ADDENDUM NO. 01
BID NUMBER 595
PIERCE TRANSIT MAINTENANCE BASE
BUILDING 4 PARKING AND FUEL & WASH CIVIL

DATE: August 18, 2020

1. Marked-up Drawing CP-111 through CP-113 (For tax application demarcation reference only)
2. Huitt-Zollars Addendum #1 Drawings dated 08/17/2020
3. Huitt-Zollars Addendum #1 Design Revisions Narrative dated 08/14/2020

DRAWING No.:	UE-111
SHEET No.:	61 OF 70

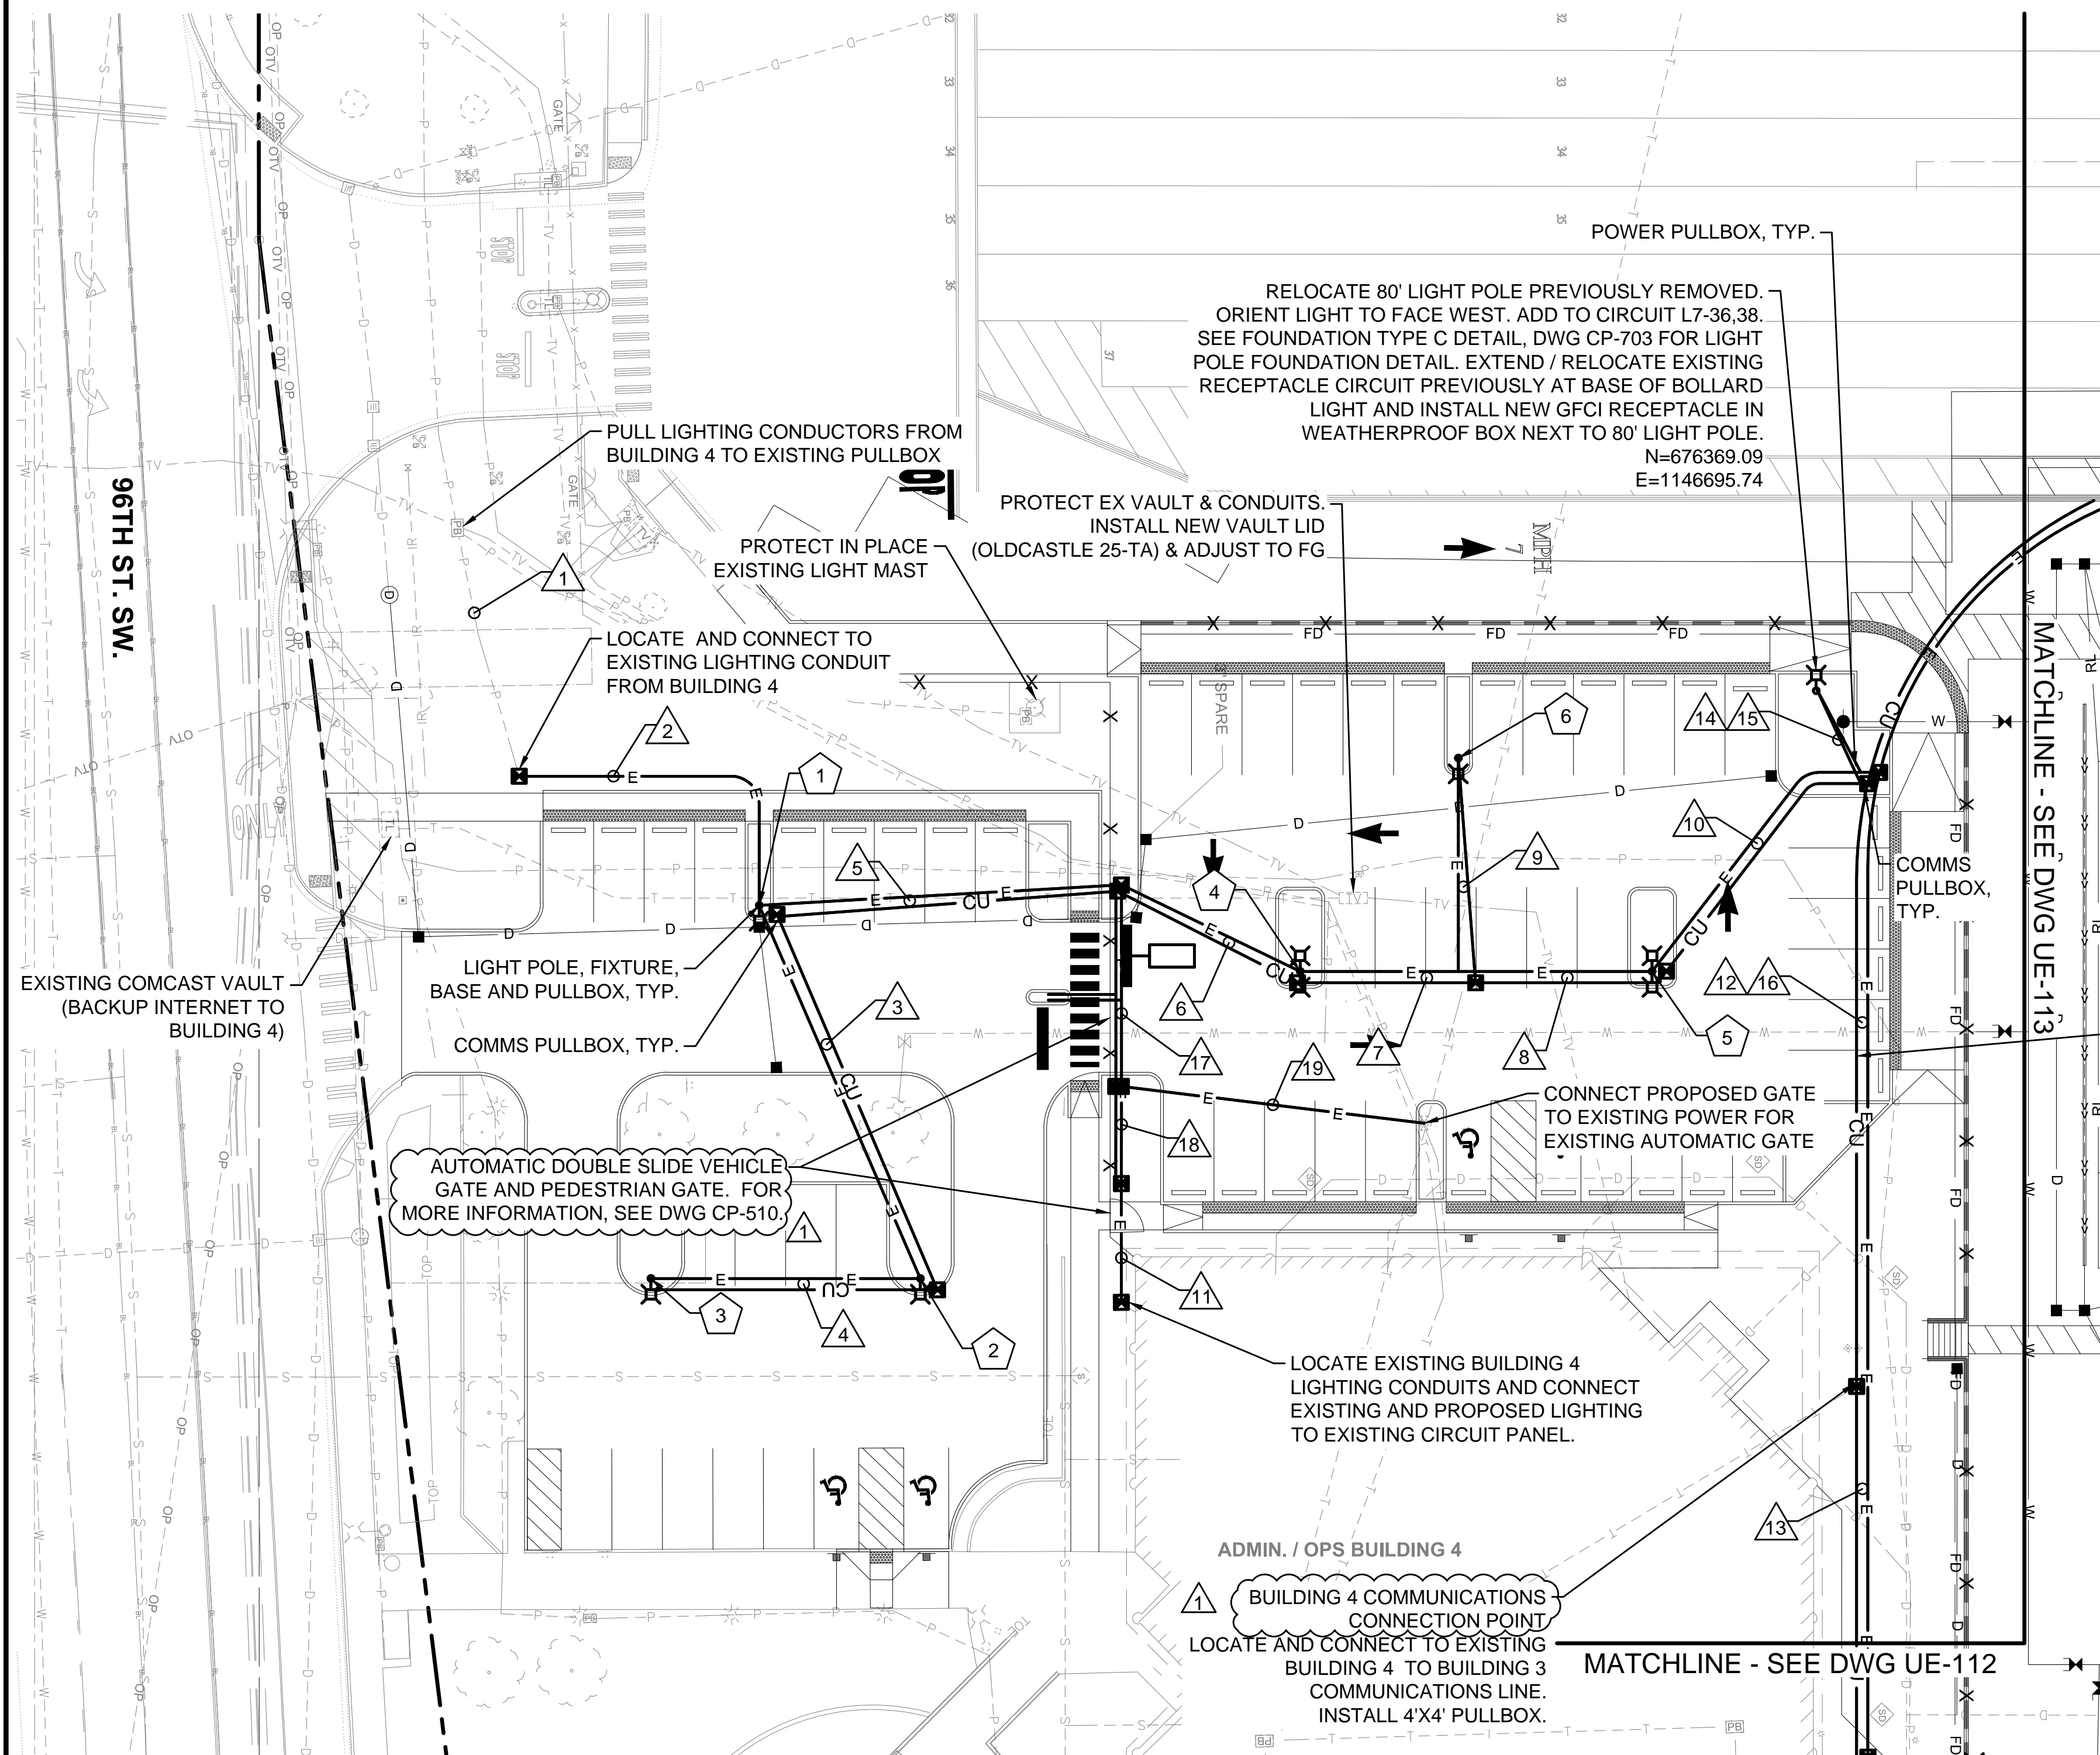
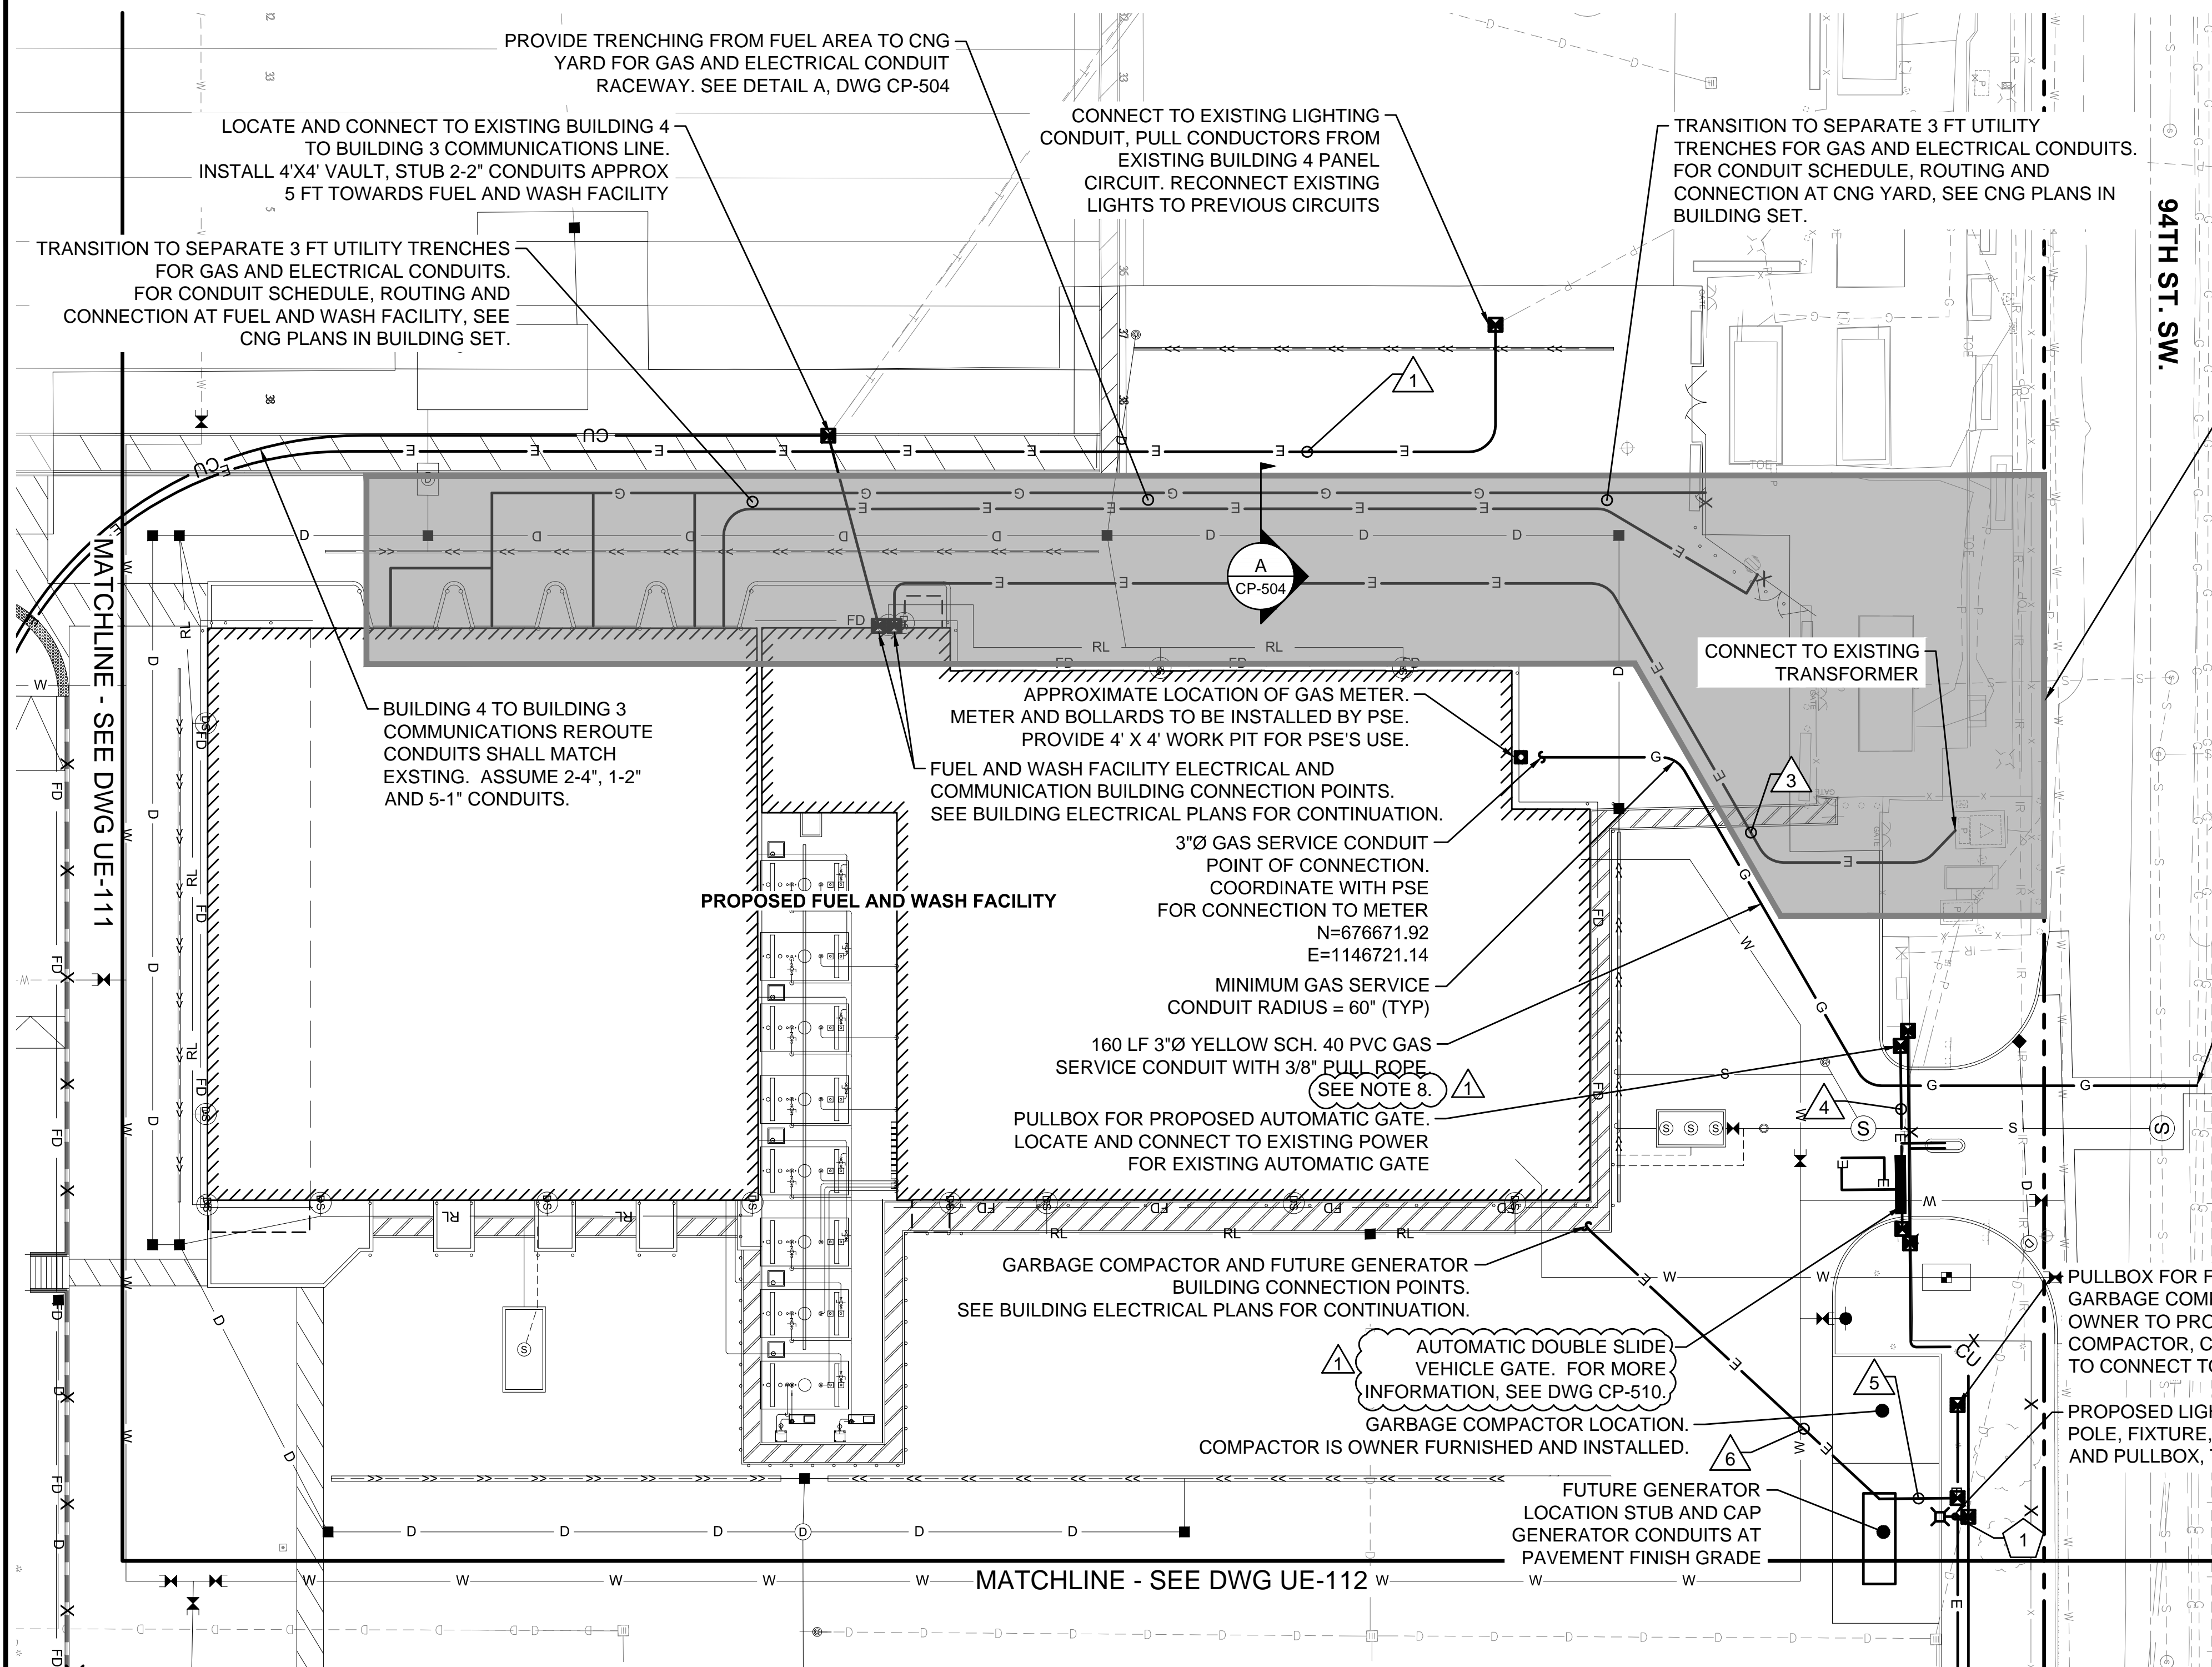
#	DWG/Spec	Description	Comment
5	CP-501	Revise Light Duty Pavement Section B.	
6	CP-501	Add joint sealant details.	
7	CP-503	Add Detail 9 and add surface mount base plate note to Detail PS-05.	
8	CP-503	Revise bollards to be schedule 40 steel.	
9	CP-504	Add "TYPICAL FENCE NOTES".	
10	CP-504	Detail A – CNG TRENCH DETAIL is Not In Contract (NIC)	
11	CP-510	Clarify gate equipment and appurtenances.	
12	CP-700	Revise ramp handrails to be galvanized.	
13	CP-701	Add reinforcement at bottom of stairs.	
14	CP-701	Revise width of wall footing.	
15	CP-703	Revise light pole base details and note number of conduits in pole bases.	
16	CP-705	Revise entire sheet.	Revise concrete paving reinforcement details.
17	CP-706	Revise concrete strength for vertically formed walls.	
Electrical			
1	UE-111 & UE-113	Add note #7, re-number notes #8 and #9.	
2	UE-111	Add callout for Building 4 communications connection point.	
3	UE-111	Add gate reference callout.
